PRODUCT BULLETIN No. 241

Window FlyScreen Frame Curvature (ED7677 & ED7678)

Example of curvature across a full length:

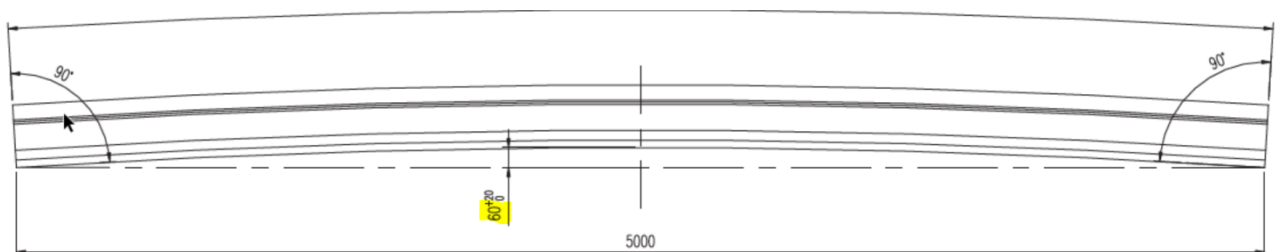
As a response to Capral customer and fabricator feedback we will be making a rolling modification to our Window Fly Screen Frame. The curvature (also known as 'bow') of the window fly screen frame will be reduced from an 80° to a 60° curvature. This adjustment will improve and assist the cutting / clamping of the fly frame and be more fabricator friendly to assemble.
